Re: St. Lucie Unit 1
Docket No. 50-335
FPL Response to Request for Additional Information for
10 CFR 50 Appendix R K1 Exemption Clarification/Request

Response to NRC Request for Additional Information

Fire Hazard Assessment of
Exposure to Safe Shutdown Raceways, St. Lucie Unit 1

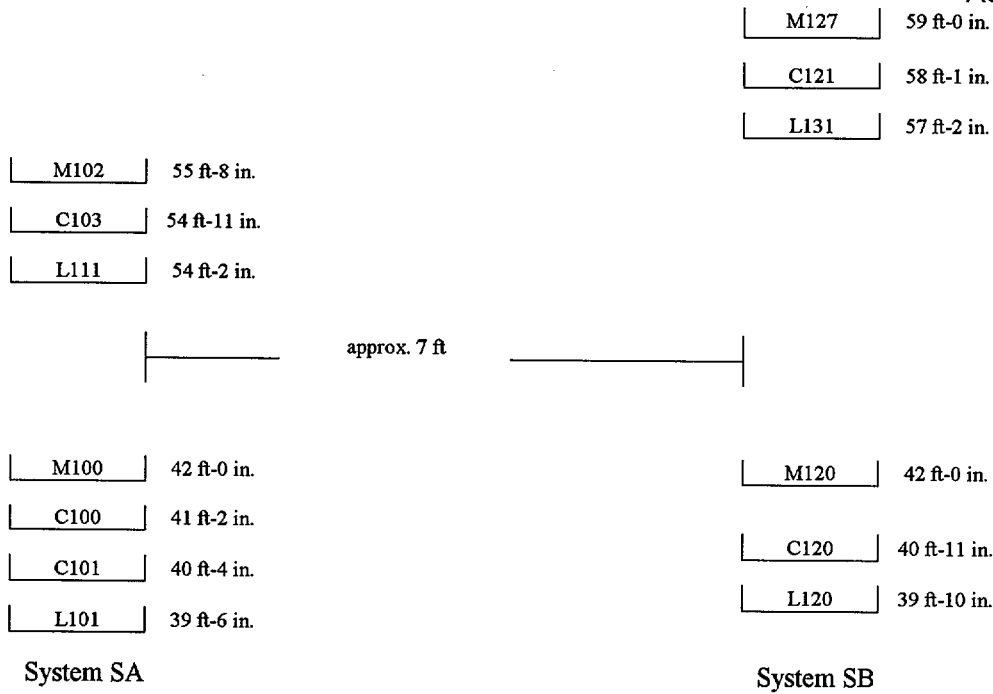
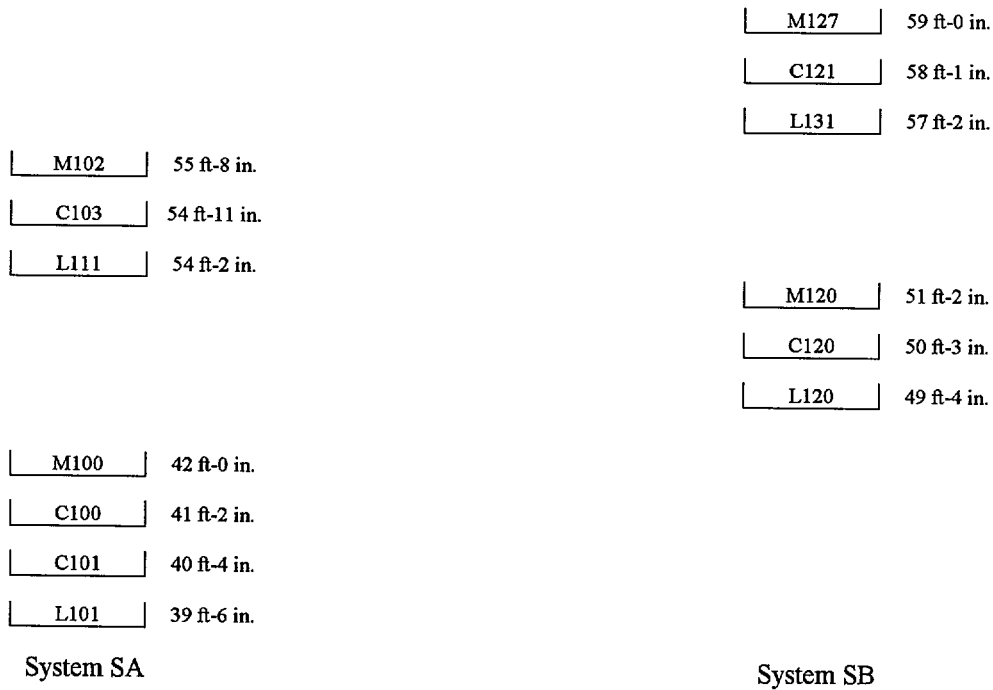
The original exemption dated February 21, 1985, addressed the entire containment annular region. FP & L has stated that corrective actions have been completed in several areas and an exemption is needed only for a segment of the containment annular region between columns 2 and 6 above and below the 45' elevation. Provide specific details of the area requiring the exemption.

The specific scope of this assessment involves the space defined by the containment structure and the interior biological shield between radial lines 2 and 6. The width of this area is approximately 20 ft. The electrical raceways in this area are divided into two separate sections defined by the divisional assignment of circuits: system SA, MA, MC and system SB, MB, MD. The electrical raceways in the containment structure are arranged with 'system' SA raceways installed along the biological shield wall (inner wall of the area). The 'system' SB raceways are installed along the outer wall of the area. Between radial lines 2 and 6, raceways are installed to allow the routing of circuits around the containment structure at both 23 ft-0 in. and 45 ft-0 in. elevations. The area is described in more detail in Attachment 3 to L-2001-267, Section 3.

The system SA and SB tray stacks are separated by a horizontal distance of approximately 7 ft. Based on these elevations, the key interactions distances are 12 ft vertically and 7 ft horizontally.

Figure 6 – Horizontal-vertical cable tray configuration

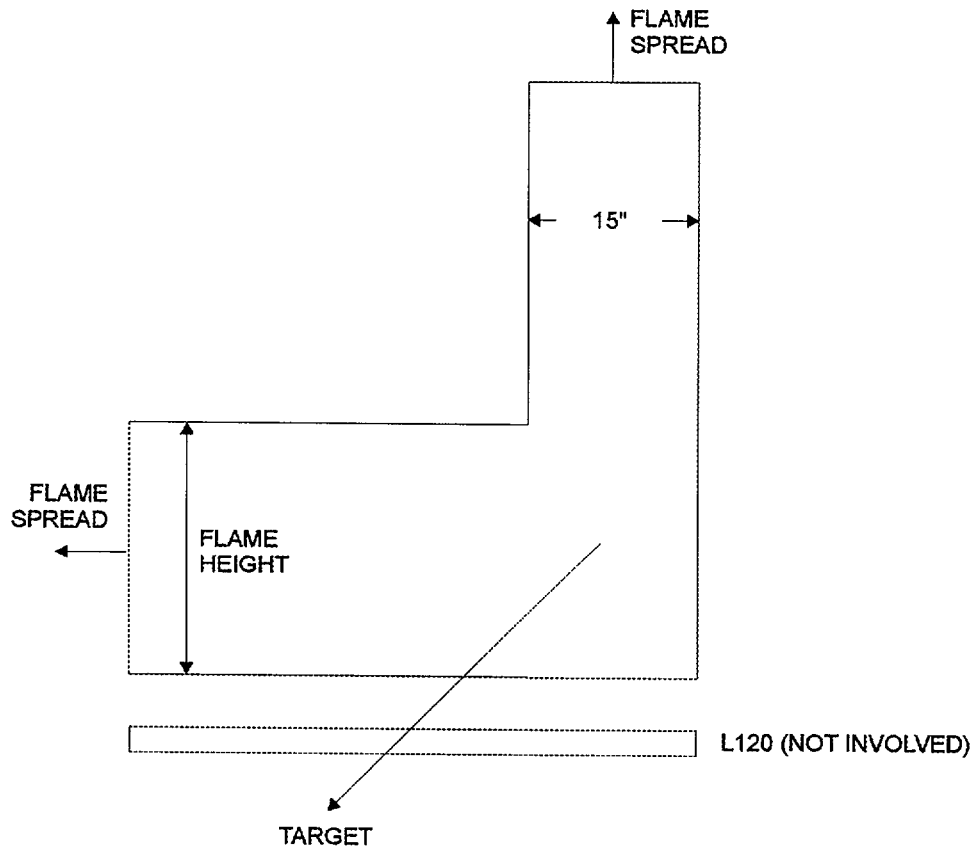
Will a fire in cable tray risers grow faster than in horizontal cable trays, and how does it affect the analysis?

Yes, fire growth in a cable tray riser would grow faster than in a horizontal tray. The vertical risers were considered in the analysis and determined to not represent the MEFS (See Section 8.2.1 of Attachment 3 to L-2001-267).
